**CITY PLAN COMMISSION**

**FILE NUMBER:** PLAT-26-000109

**REQUEST:** An application to replat a 7.206-acre tract of land containing all of Lot 36 in City Block 8262 to create one 1.002-acre lot and one 6.204-acre lot on property located on Cederdale Road at J.J. Lemmon Road, southwest corner.

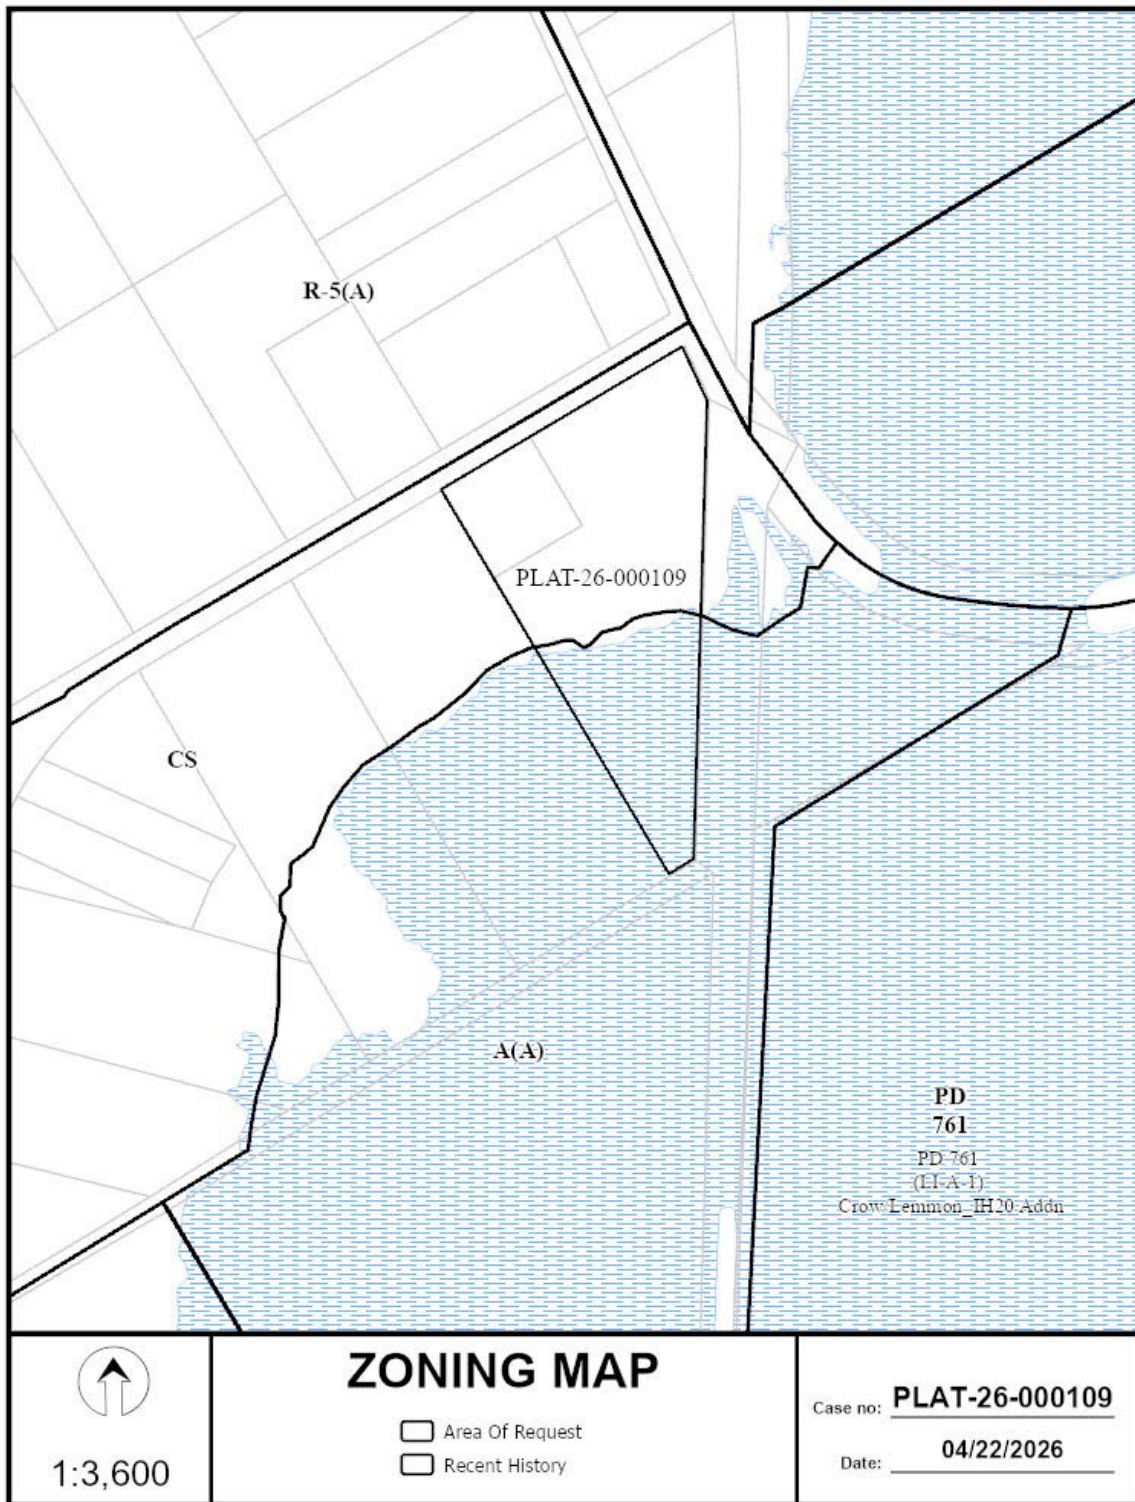
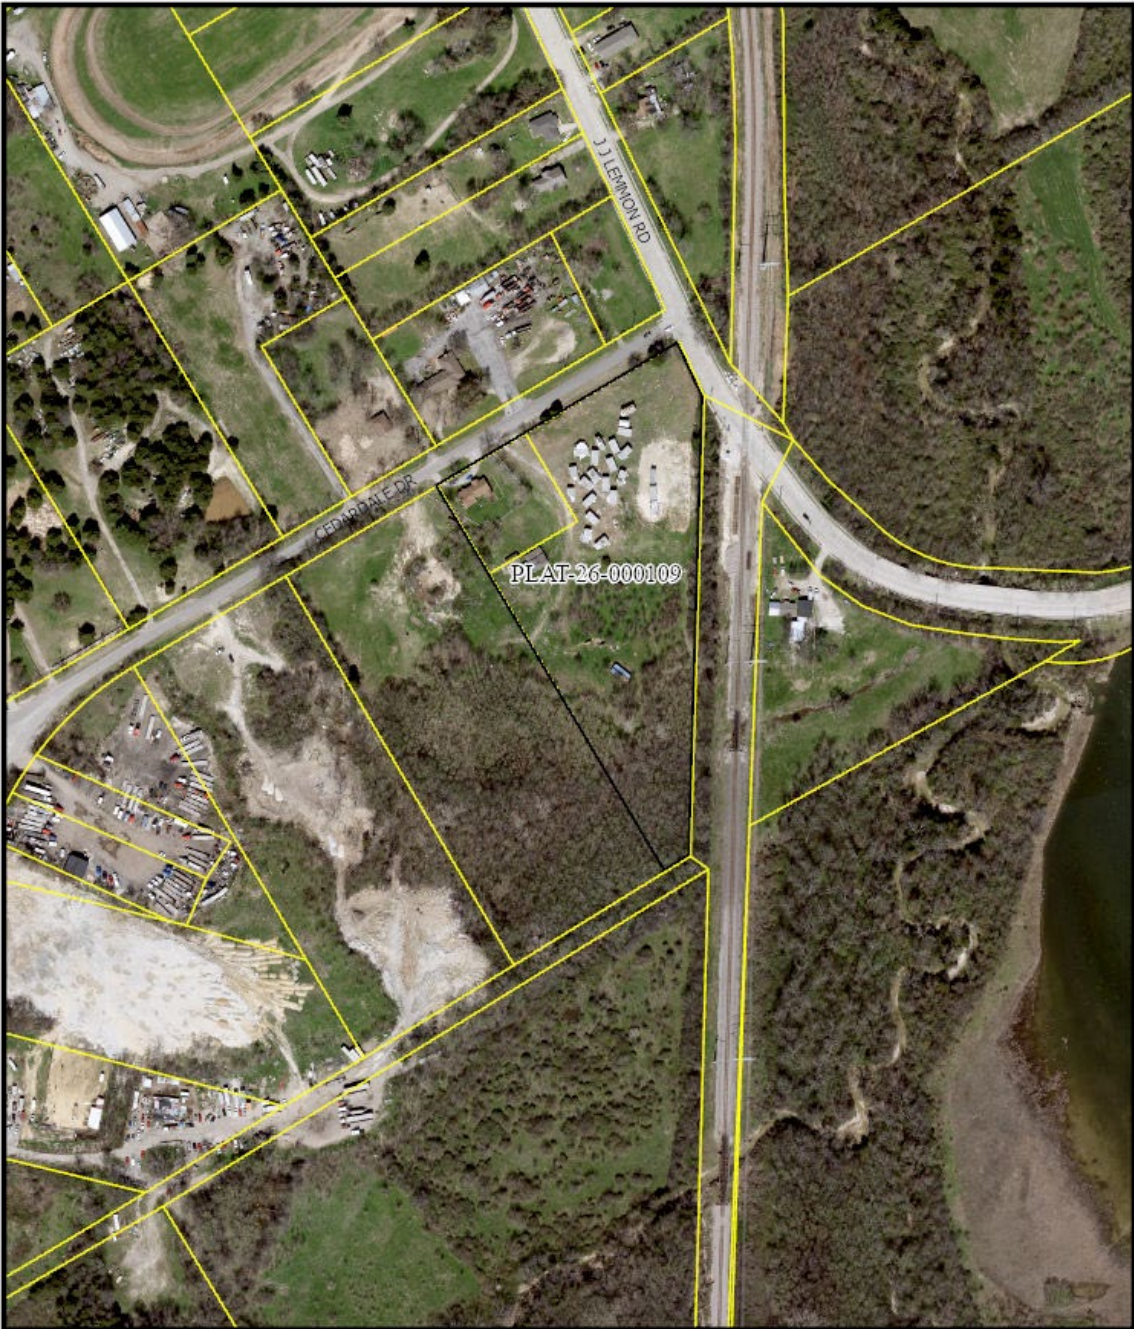
15. On the final plat, dedicate a minimum 5-foot by 5-foot corner clip (via fee simple or street easement) at the intersection of JJ Lemmon Road & Cedardale Road. Section 51A 8.602(d)(1)
16. A larger corner clip may be requested during engineering plan and traffic review to accommodate an adequate turning radius, or to maintain public/traffic appurtenances, within the area of the corner clip. *Section 51A 8.602(d)(1), 51A 8.608(a)*
17. Coordinate with **Burlington Northern Santa Fe Railroad** which may be affected by this development.

18. On the final plat, determine the 100-year water surface elevation across this addition.
19. On the final plat, dedicate floodway easement, floodway management area or floodway easement (within common area), with the appropriate easement statement included on the face of the Plat. 51A 8.611(d); DWU Floodplain Management; Drainage Design Manual Addendum V

20. On the final plat, include additional paragraph in Owner's Certificate (pertaining to the floodplain). 51A 8.611(d); DWU Floodplain Management; Drainage Design Manual Addendum V
21. On the final plat, specify minimum fill and minimum finished floor elevations. *Section 51A-8.611(d), Trinity Watershed Management.*
22. On the final plat, show the natural channel set back from the crest of the natural channel. *Section 51A-8.611(d), Trinity Watershed Management.*
23. Prior to submission of the final plat, set floodway monument markers and provide documentation that the monuments have been set. *Section 51A-8.617(d)(1), (2), (3), and (4)*
24. Provide information regarding Fill Permit or Floodplain Alteration Permit if such permit is applied for.

30. Prior to the final plat, please remove fence encroachment along Cedardale Road and provide documentation and pictures to Real Estate
31. On the final plat, change "Cedardale Road (FKA Riverside Boulevard)" to Cedardale Drive (FKA Riverside Drive FKA Duncanville-Wheatland Road)". *Section 51A-8.403(a)(1)(A)(xii).*
32. On the final plat, identify the property as Lot 36A & Lot 36B in City Block 8262.
